REV NO.	TITLE	CONT ON SHEET	SH NO.
P3K-AL-0327-A01	TEST INSTRUCTIONS FOR AUXILIARY SPEED REFERENCES	11	10
CONT ON SHEET 11	FIRST MADE FOR EHC MARK II (AUXILIARY SPEED CONTROL UNIT)		
Assm. 115D2219 Sch. 115D2216 Patchboard No. _____ PCR _____		REVISIONS	
<u>TEST PROCEDURE</u>

TEST INSTRUCTIONS FOR AUXILIARY SPEED REFERENCES

FIRST MADE FOR EHC MARK II (AUXILIARY SPEED CONTROL UNIT)

FIGURE B

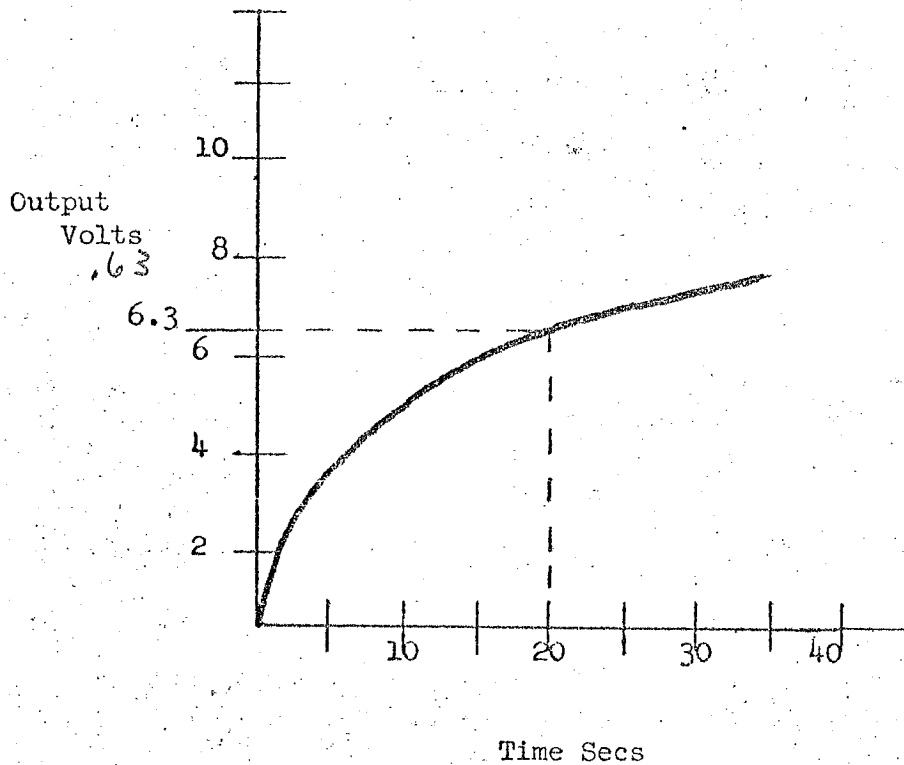
Grd. TP51 and apply a 0 to -7.500 VDC voltage step into pin 28 by switching S6 up. Observe the step response time constant of the rising exponential as shown in Fig. B. It must be between ~~18 and 22 sec.~~

For acceptance, the time constant must be between 18 and 22 sec.

26.1 ± 9.3 sec

between 17 sec. and 35 sec.

17 35
